# Assessment of Dam Safety Coal Combustion Surface Impoundments (Task 3) Draft Report

**Kentucky Utilities**

**Ghent Generating Station**

December 8, 2009

FIGURE 10A

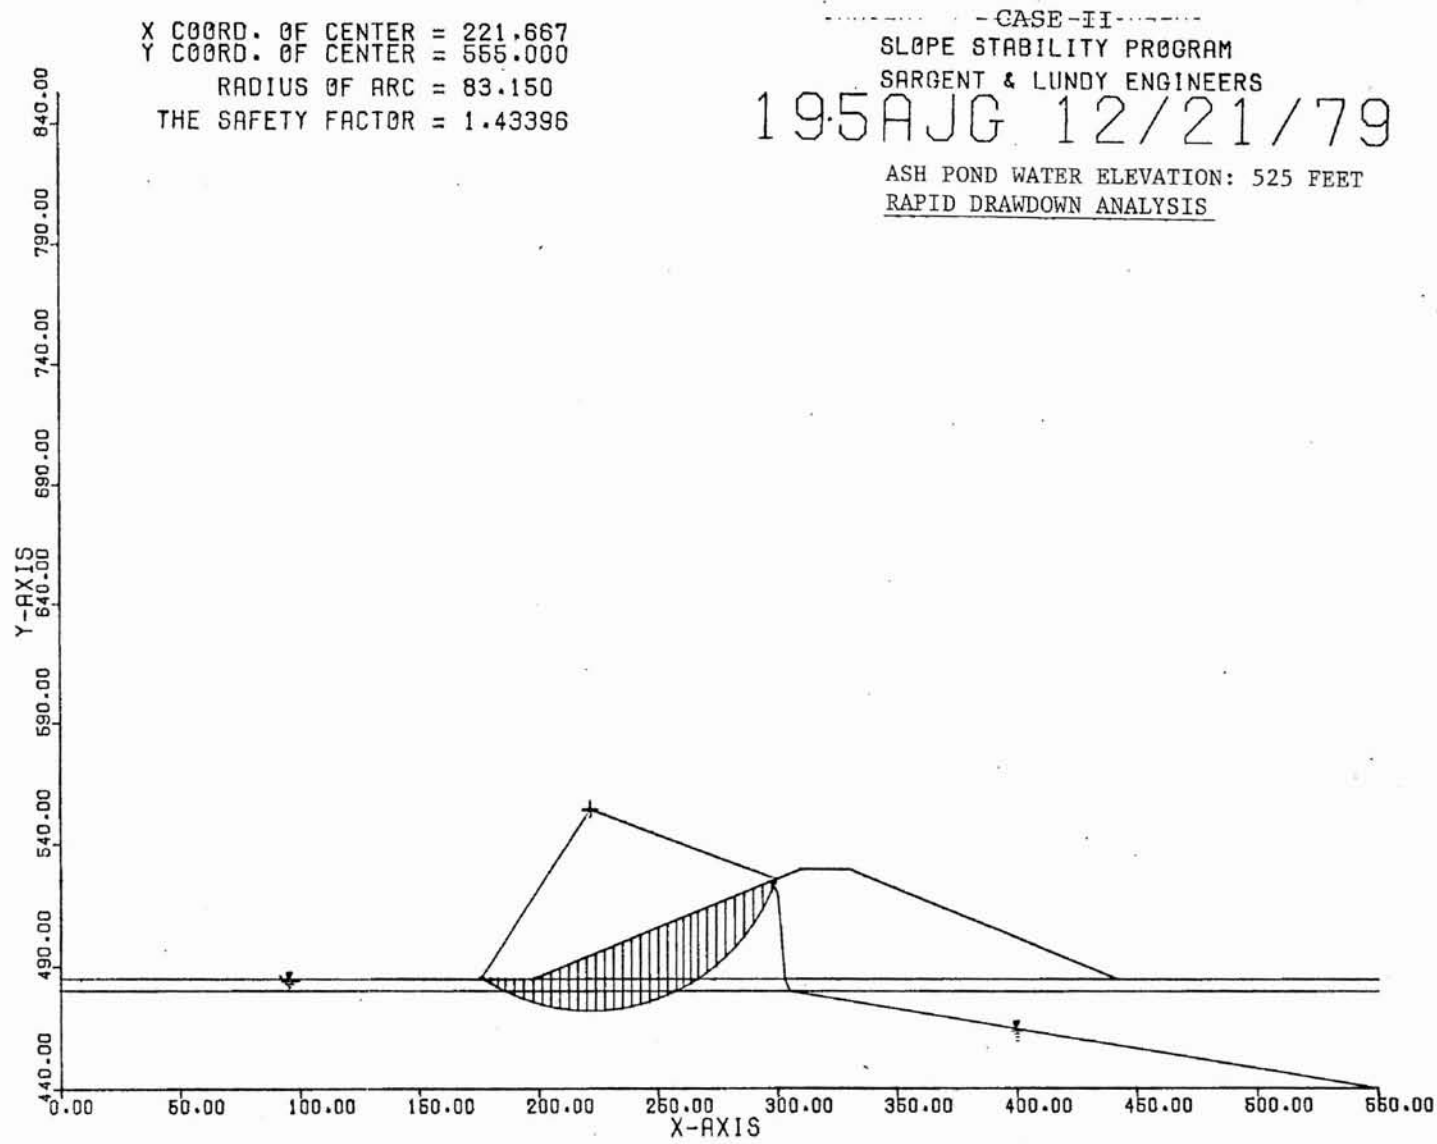
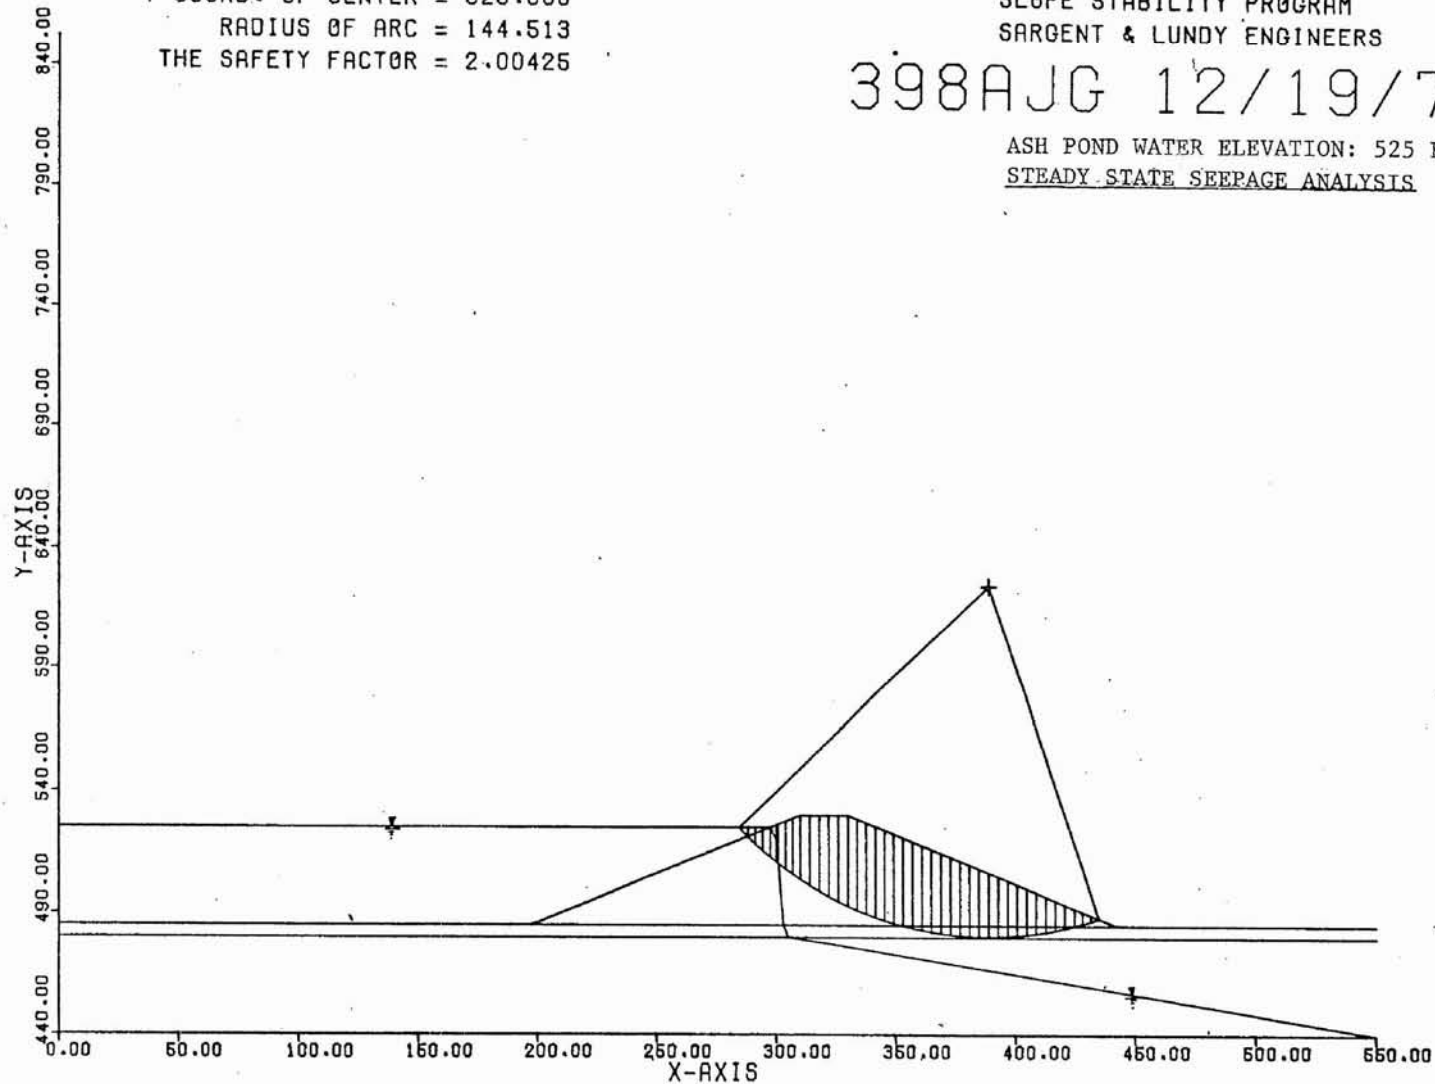
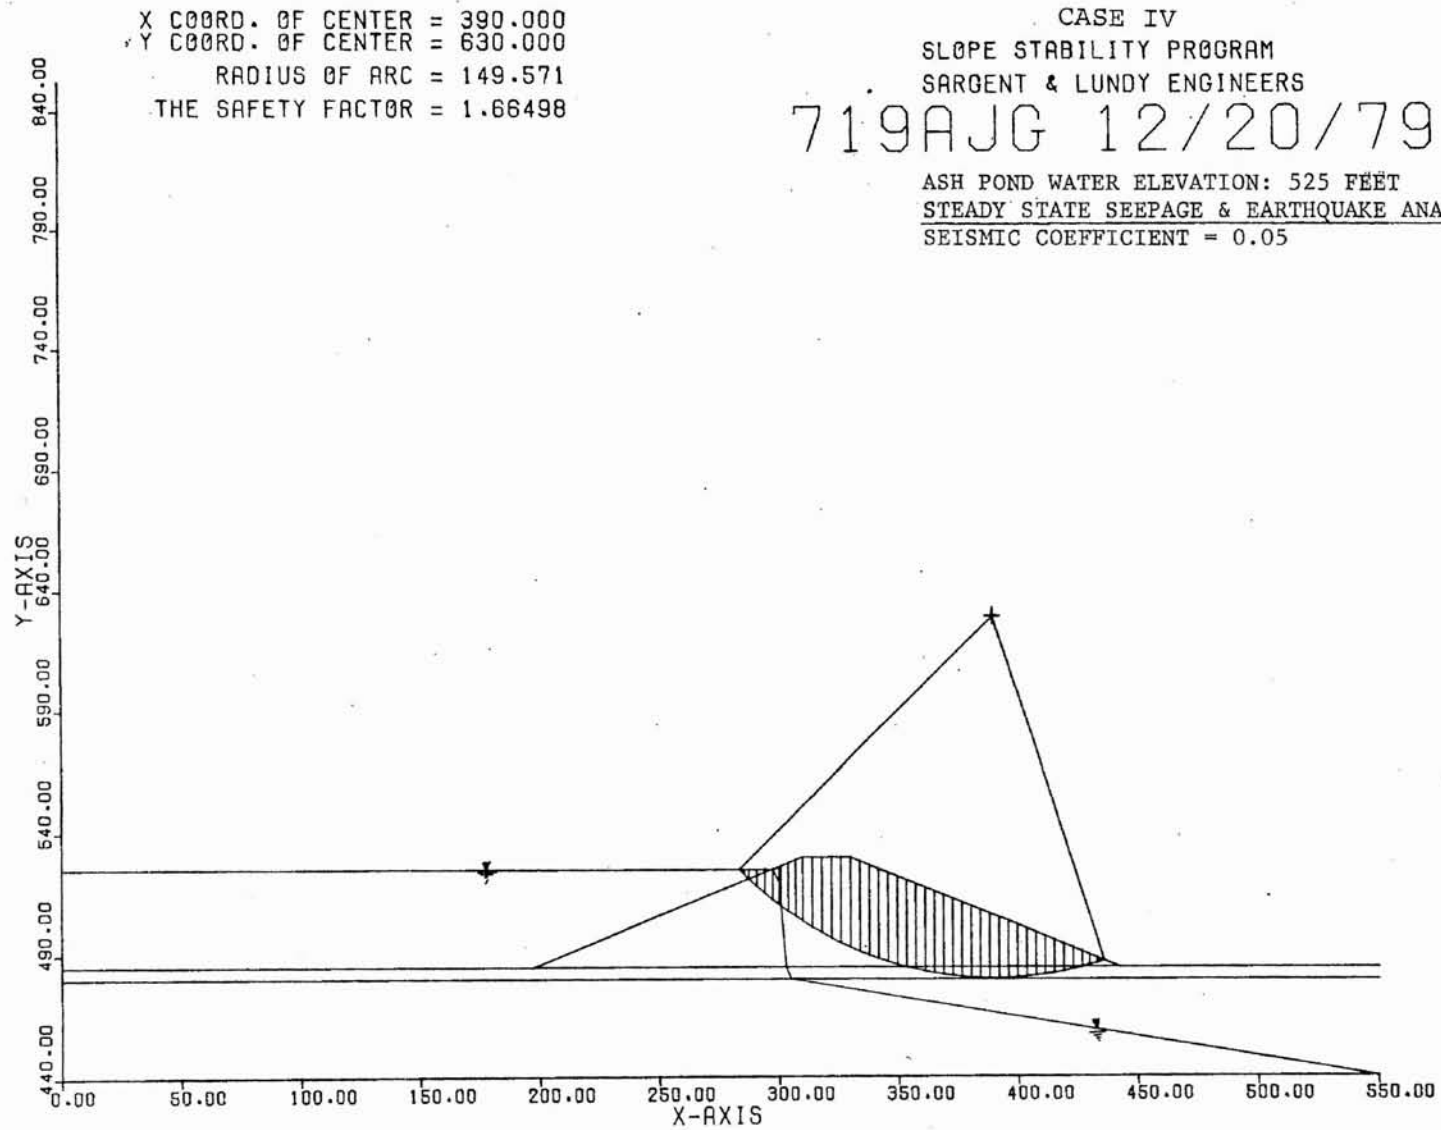
For the typical sections of the embankment (west and north sides of the impoundment) the Sargent & Lundy analyses resulted in the factors of safety summarized in Table 7. Figures 10a, 10b, and 10c show the stability analysis cross sections.

During construction, the east embankment experienced lateral spreading and slope stability issues because of the soft clay layer within the limits of the former stream bed. Sargent & Lundy revised the cross section in this area to include berms buttressing the toe on both the upstream and downstream sides of the dike. With these berms, the factors of safety summarized in Table 8 were determined.

PROJECT NO.  
20085.2030  
 DATE: 12/2009  
 FIGURE 11

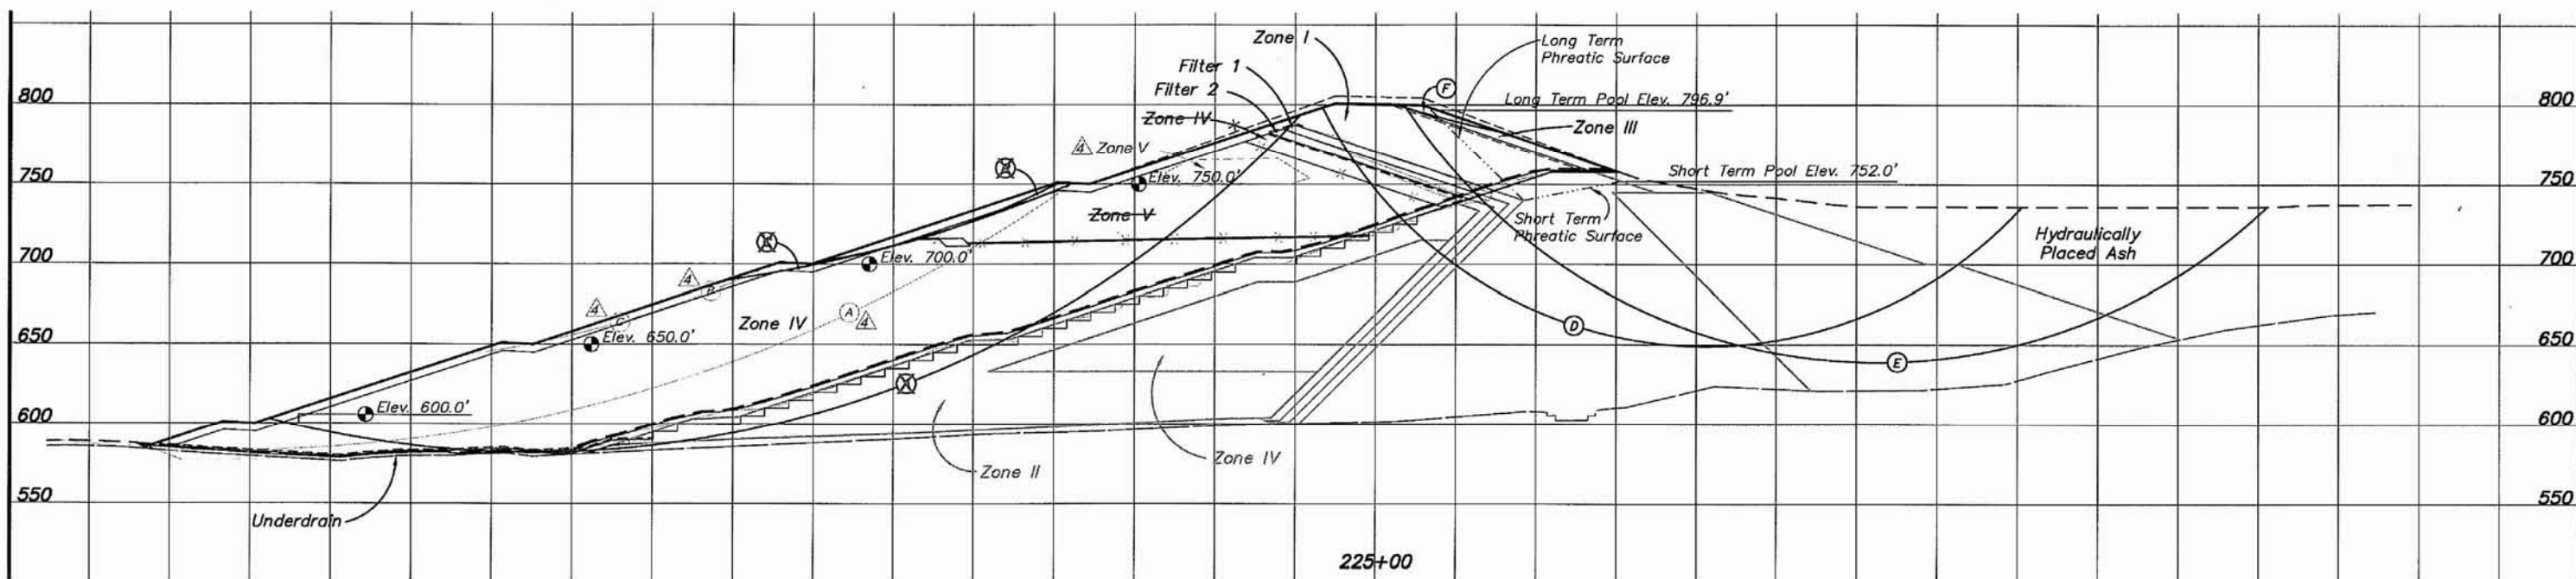
CHA was provided with the Engineering Design Report for the raising of ATB #2 as well as record drawings showing the actual placement of zoned material in the embankment. Figure 11 was taken from the record drawings and shows the stability analyses and zones of materials used for the embankment construction. Table 9 summarizes the soil properties used for steady state conditions in analyzing the embankment. Descriptions of the soils represented by zone numbers were taken from technical specs provided in the Engineering Design Report.
